1 - 3 SWAN STREET MANCHESTER M4 1LJ

ELEVATIONS

DWG No: A.02.2

Rev: H DATE: 17/04/2023

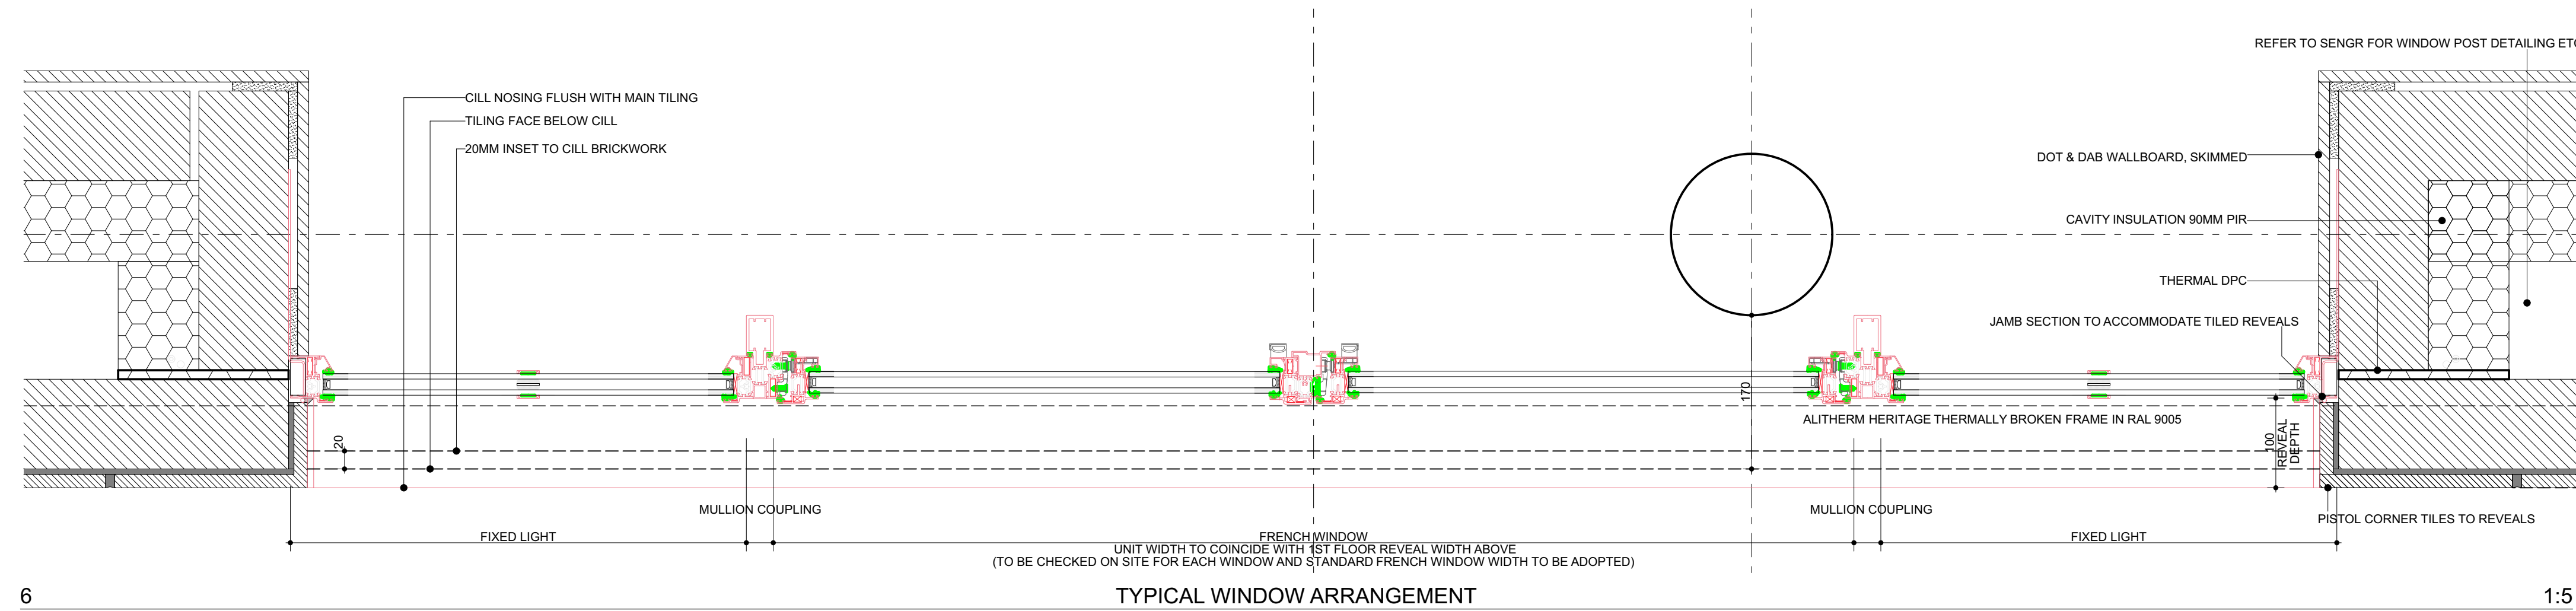
REV G: 230413 EXPANSE OF BRICKWORK ABOVE SHOPFRONT BEAM NOW FULLY EXPOSED, ELEVATION / PROPOSED FASCIA DETAIL AMENDED TO SUIT REQUIRED CONCEALMENT

REV H: 230417 VARIATIONS IN BRICK ALIGNMENT ABOVE RING BEAM AFFECTING FASCIA DETAIL, AMENDED TO SUIT

LOWER FASCIA CLAD WITH GLAZED TILES TO COORDINATE WITH SOLID PANELS BELOW, IN LIEU OF BLACK ALUMINIUM FASCIA

GLAZING BARS TO FRENCH WINDOW FANLIGHTS CHANGED FROM 4X2 TO 2X2 AND ON OLDHAM STREET FIXED TRANSOM SASH FROM 2X2 TO 1X2, TO SUIT FRAME ASSEMBLY PROPORTIONS, AS A CONSEQUENCE OF REVISION G.
